Amendment A001
⚠ 3/6/15 Contract negotiation revisions and NPDES compliance

U.S. DEPARTMENT OF TRANSPORTATION
FEDERAL HIGHWAY ADMINISTRATION
CENTRAL FEDERAL LANDS HIGHWAY DIVISION

**DANIEL K. INOUE HWY
EROSION AND SEDIMENT
CONTROL PLAN
227+00 to 242+00**

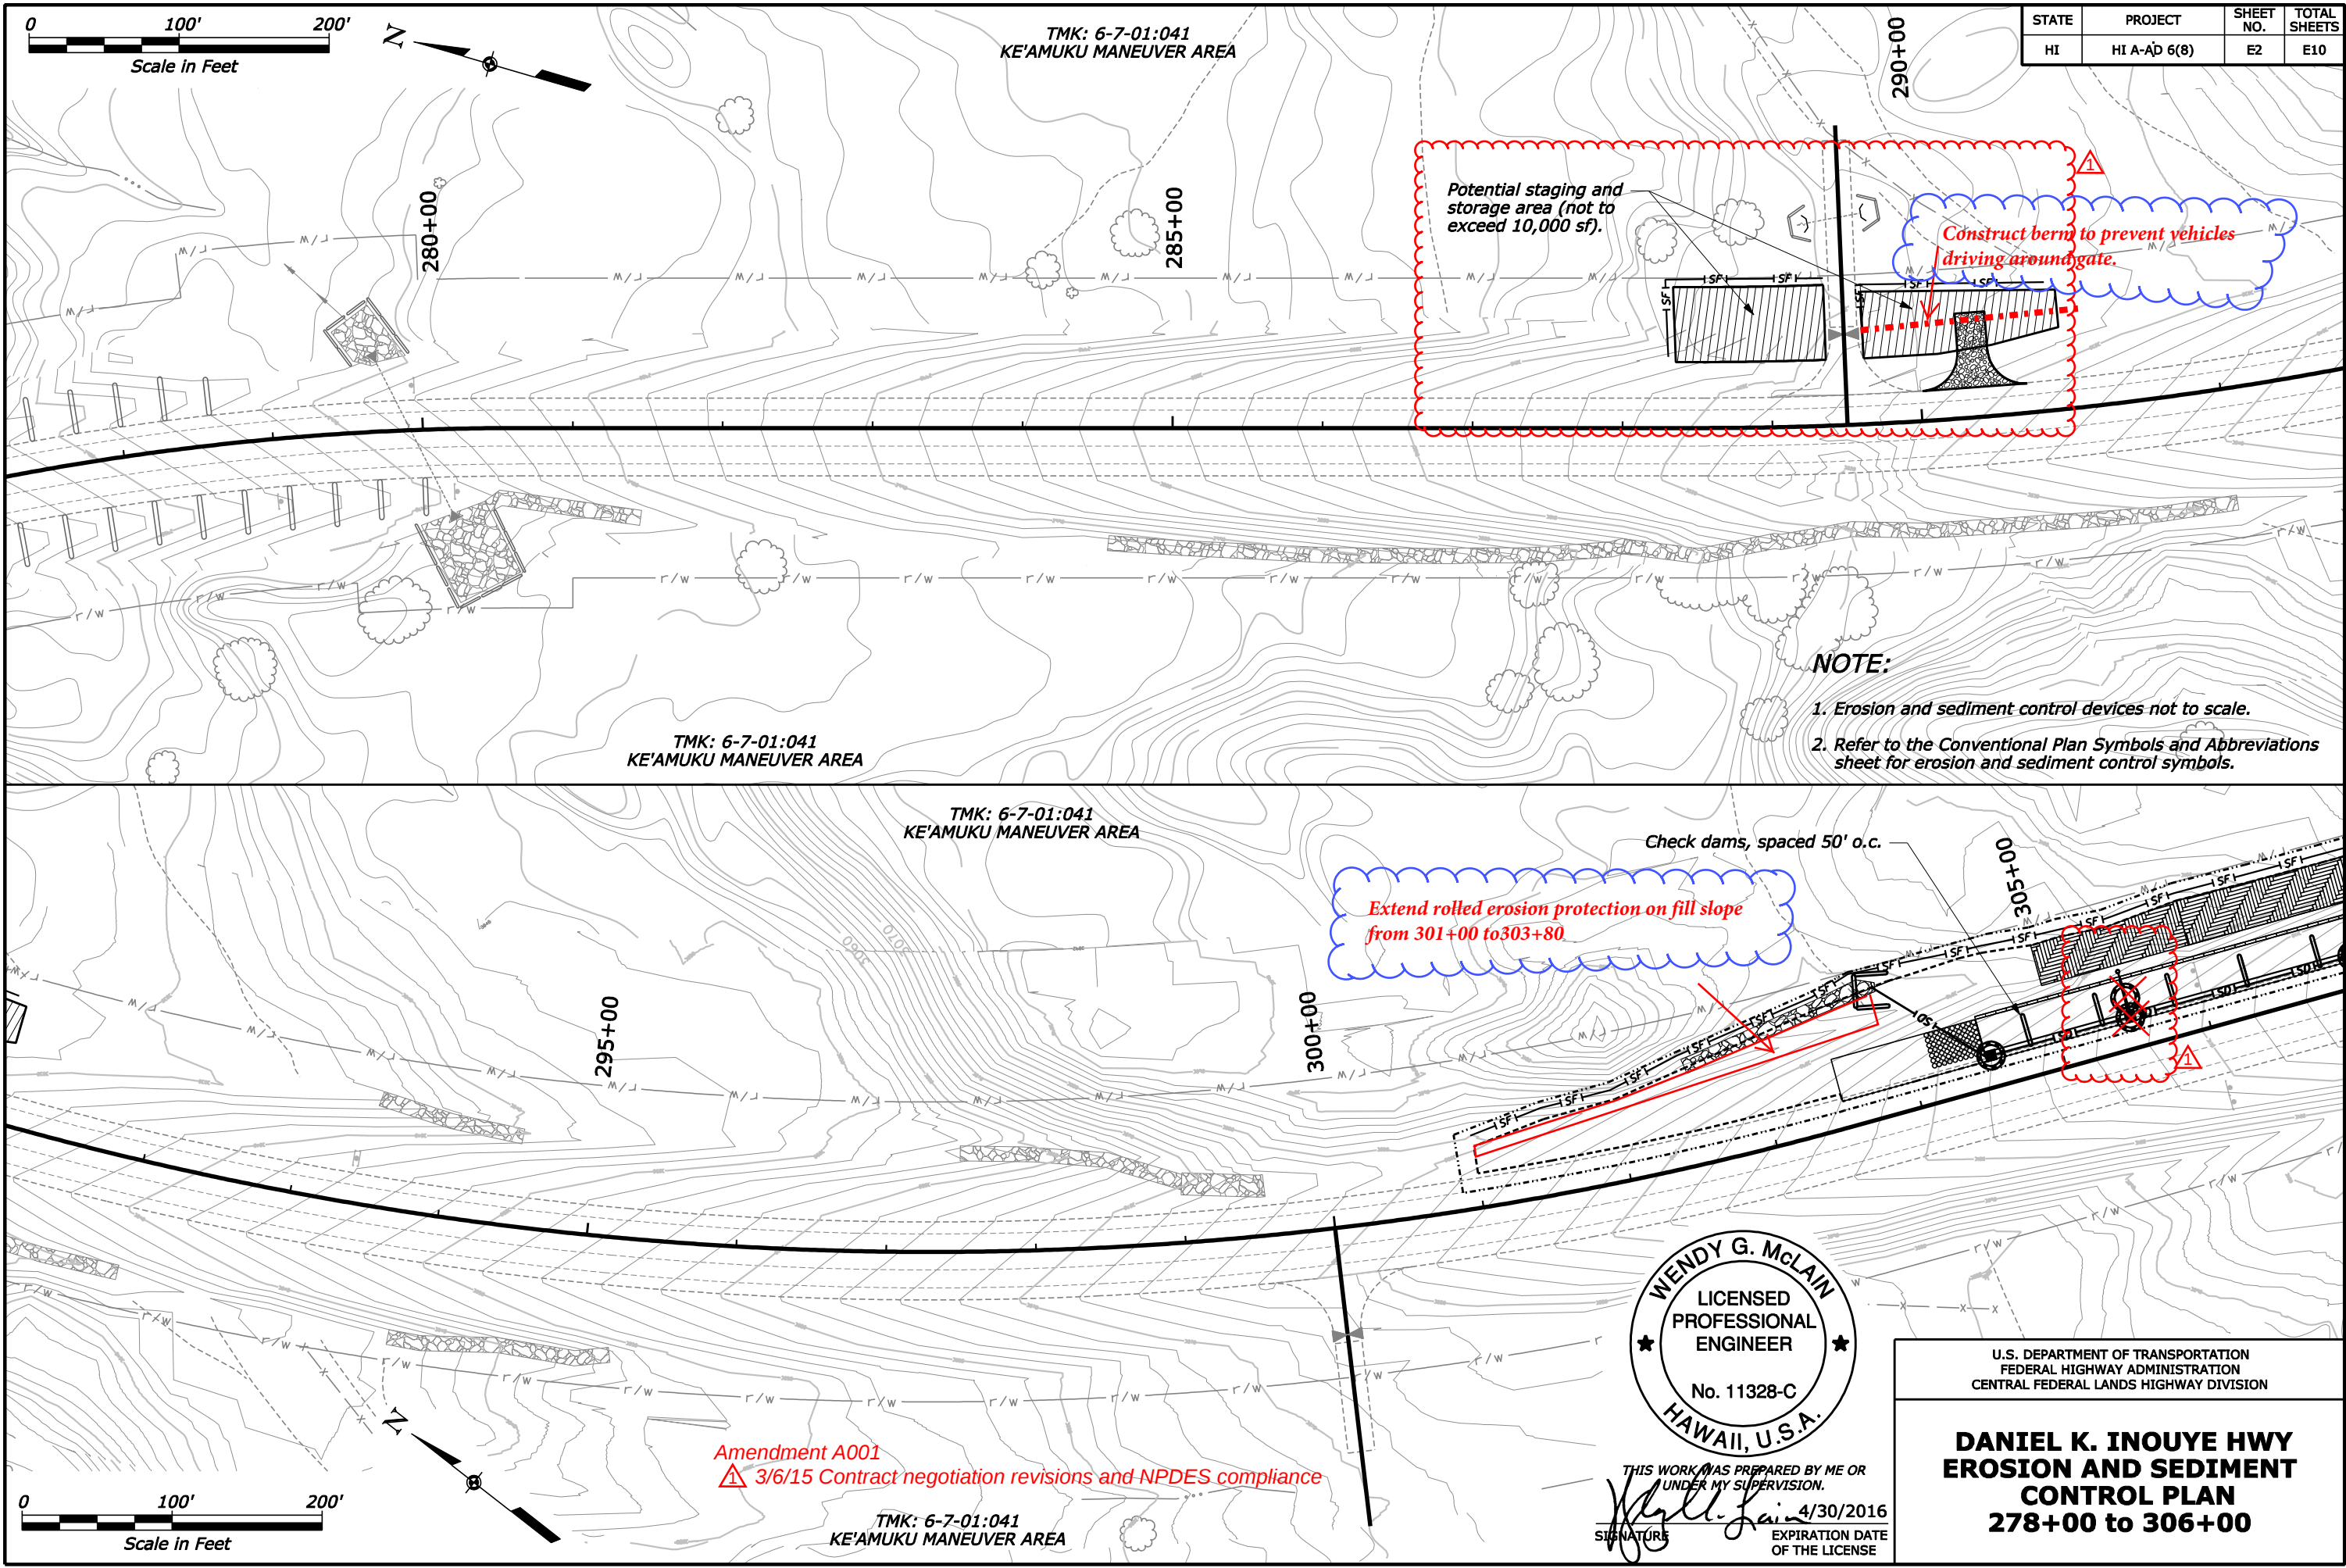
Existing silt fence, typ.
Maintain or replace as
necessary.

**DANIEL K. INOUE HWY
EROSION AND SEDIMENT
CONTROL PLAN
558+00 TO 586+00**

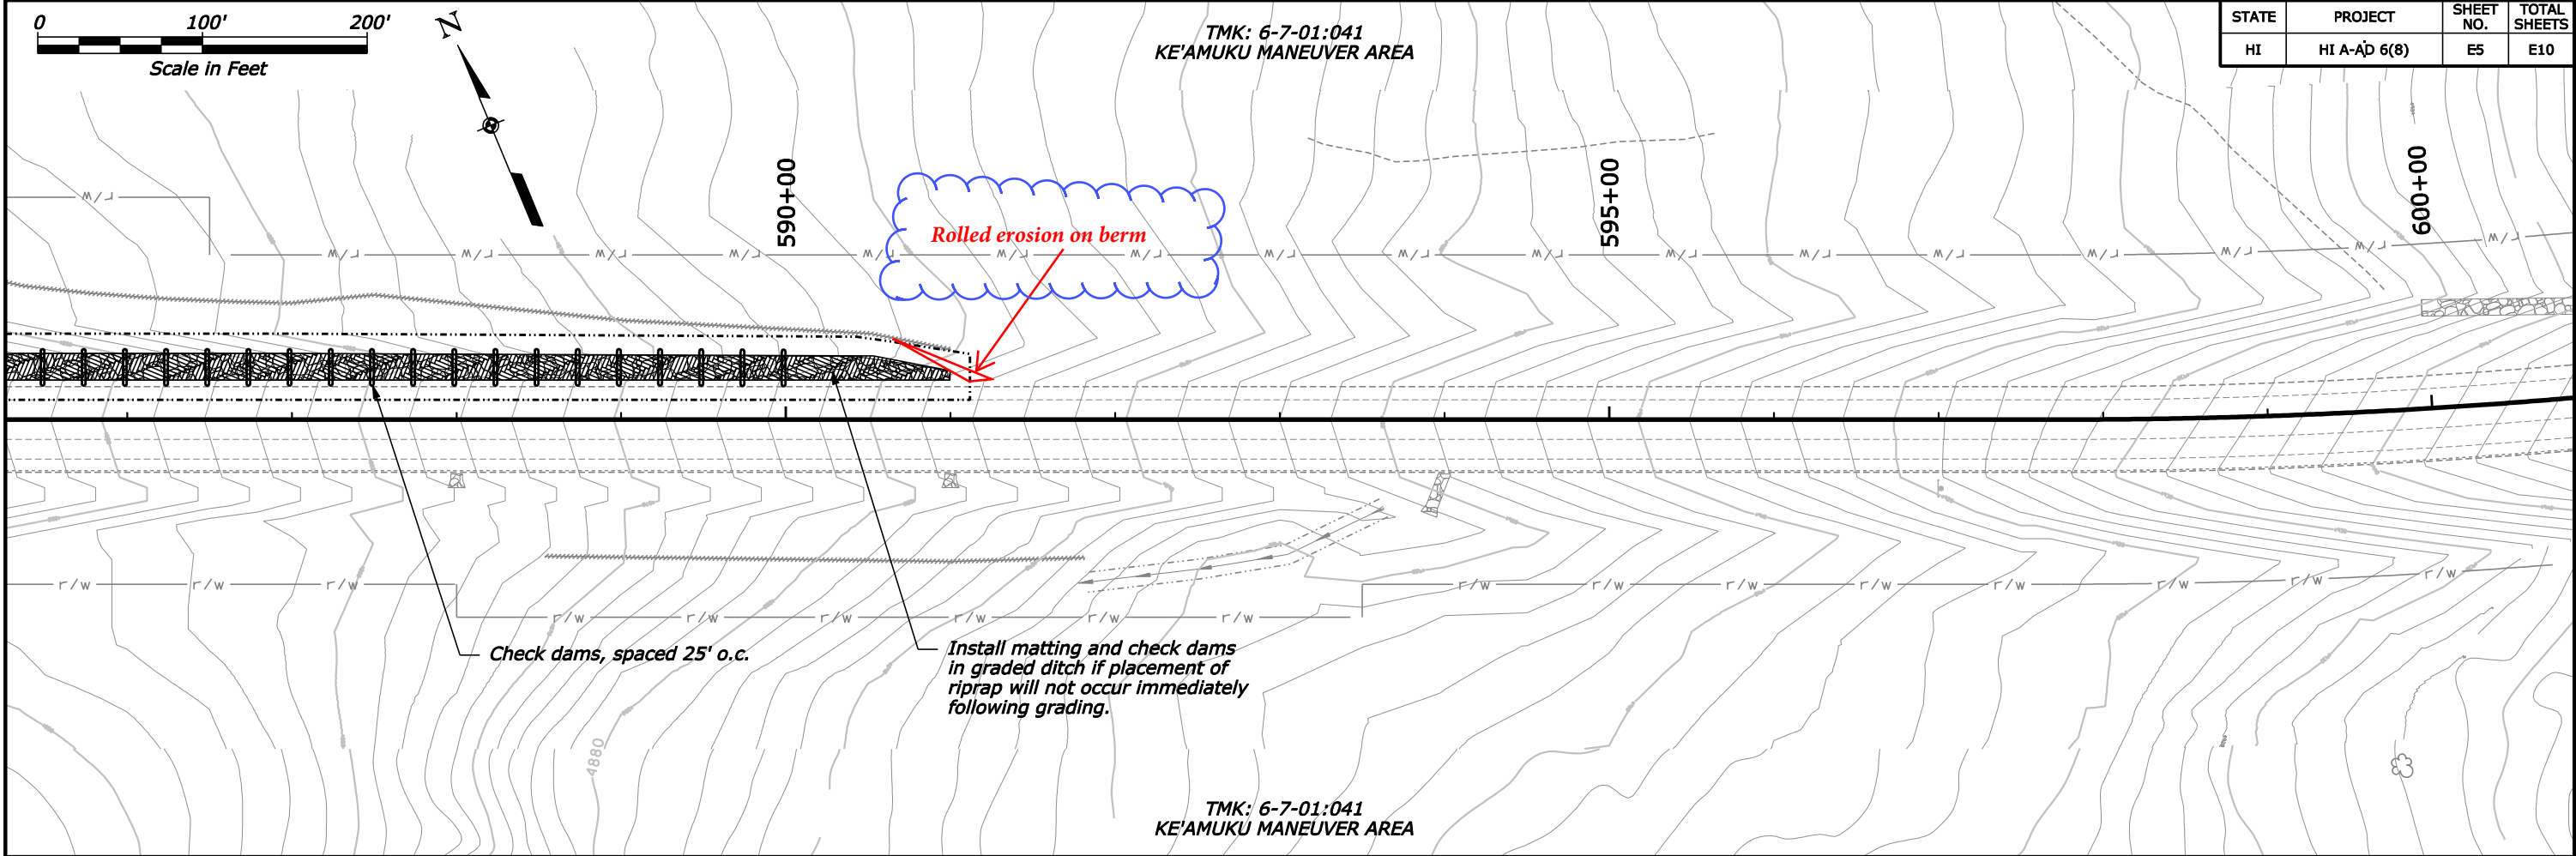
Add 20' of soil erosion log

Install matting and check dams in graded ditch if riprap will not be placed immediately following grading.

NOTE: Amendment A001
3/6/15 Contract negotiation revisions and NPDES compliance

**DANIEL K. INOUE HWY
EROSION AND SEDIMENT
CONTROL PLAN
632+00 to 647+00**

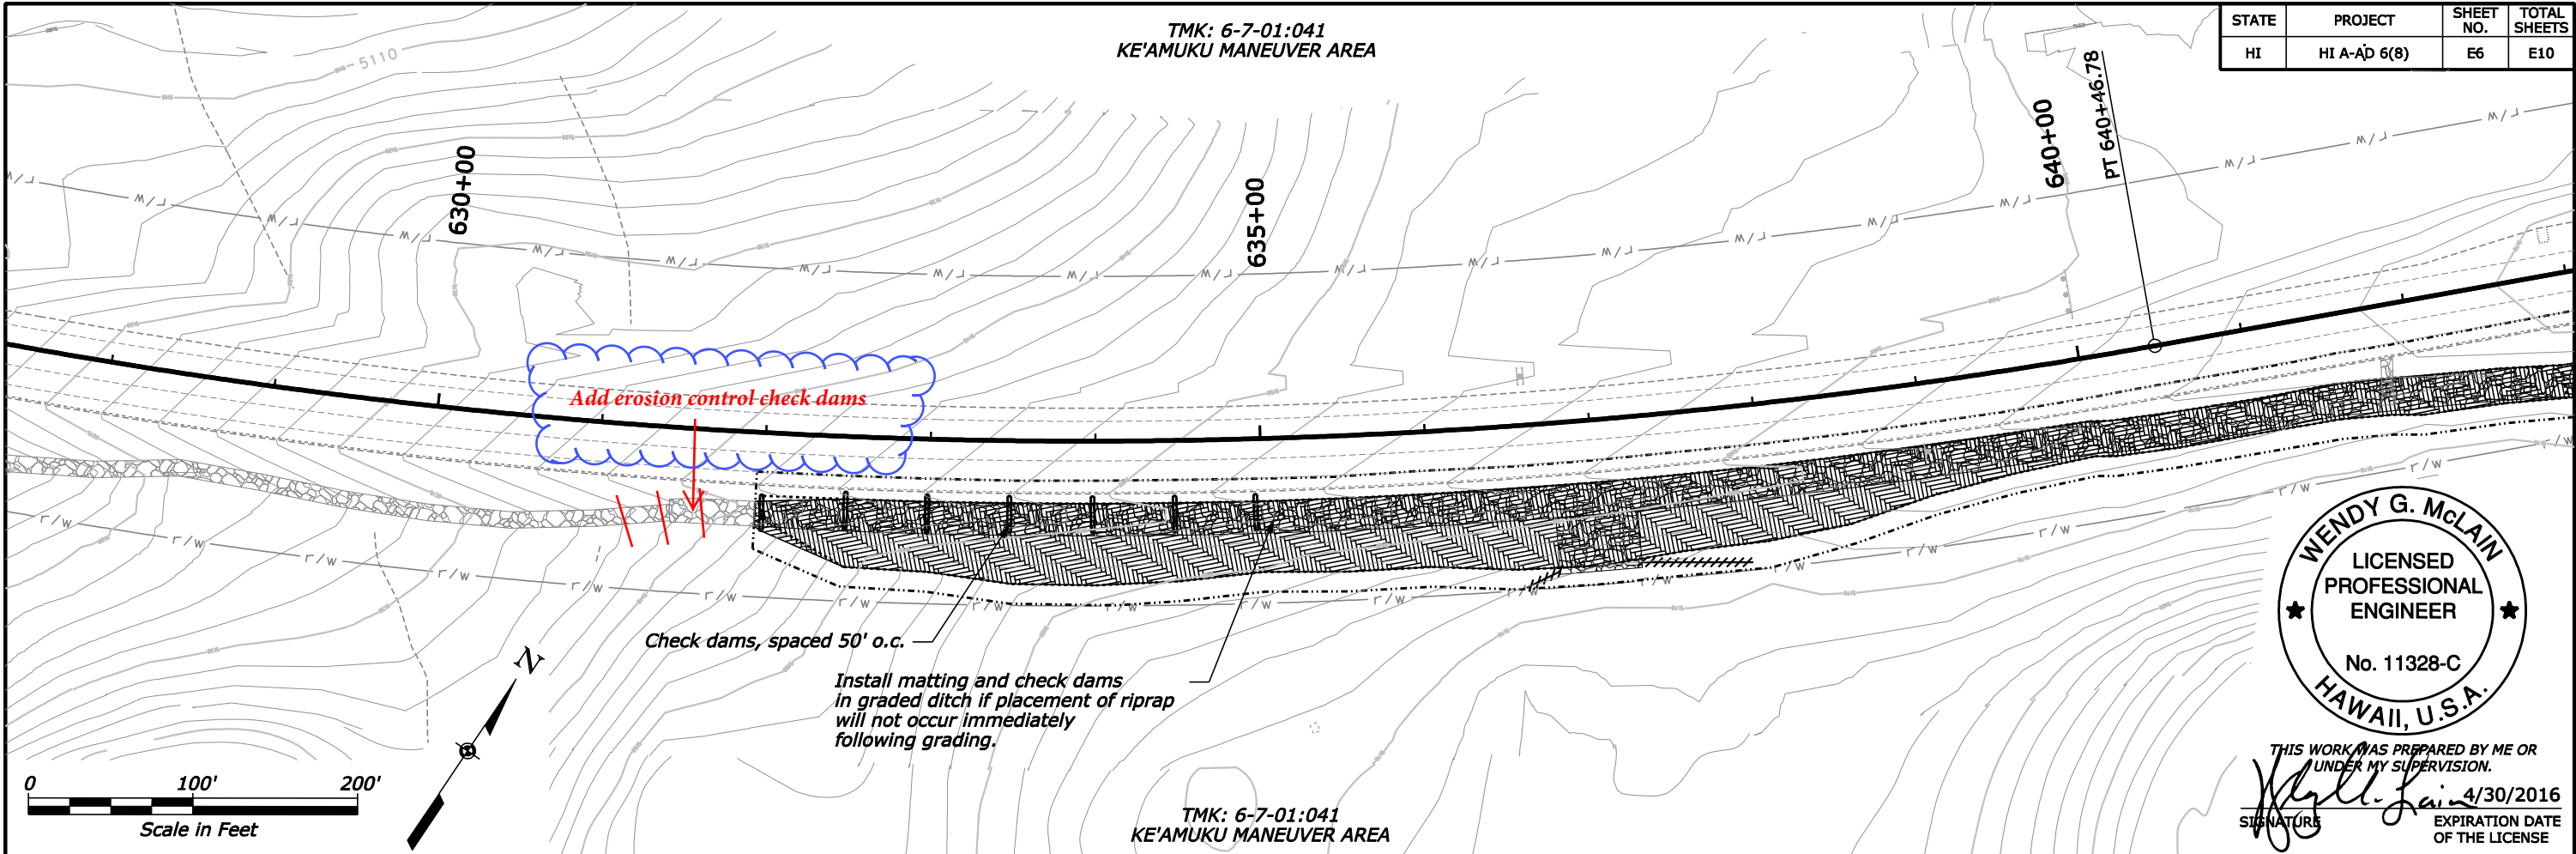
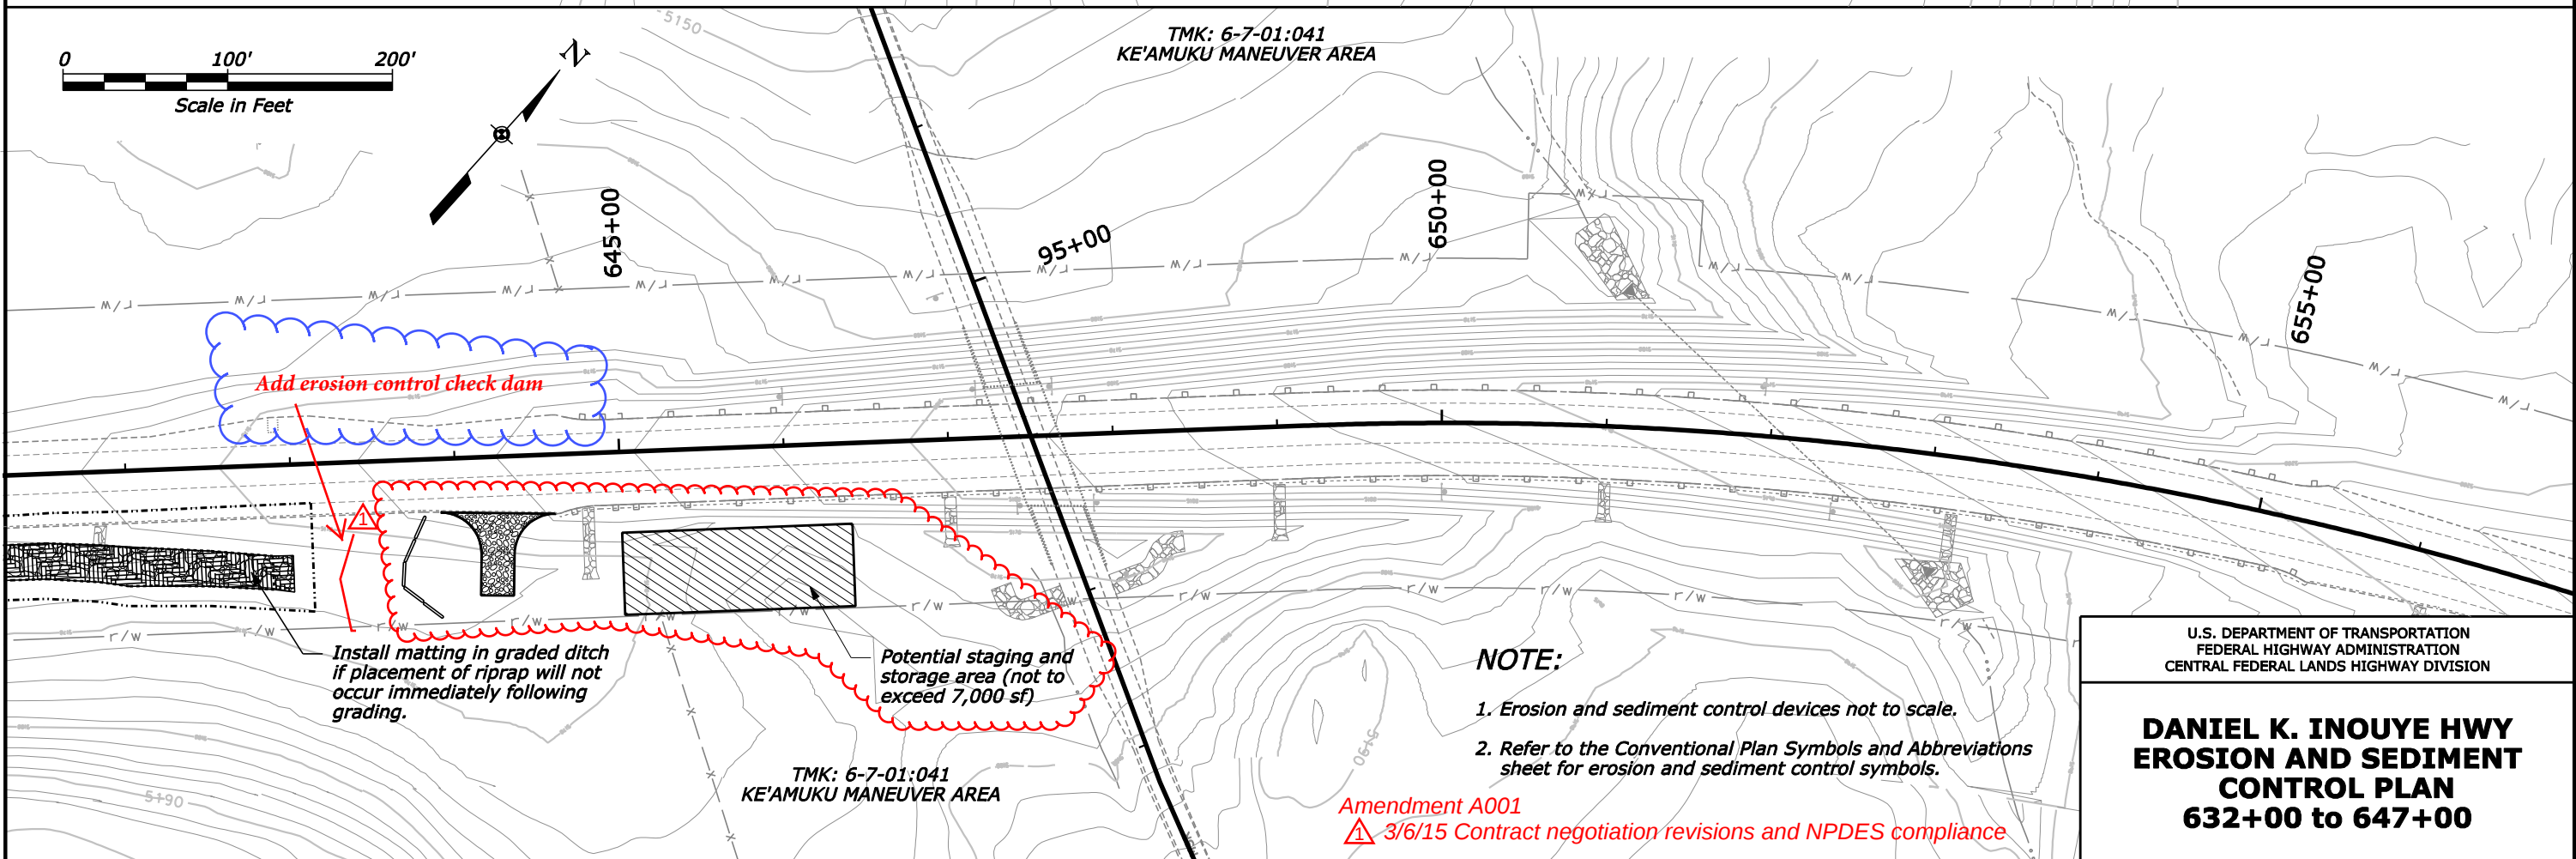
Amendment A001

3/6/15 Contract negotiation revisions and NPDES compliance
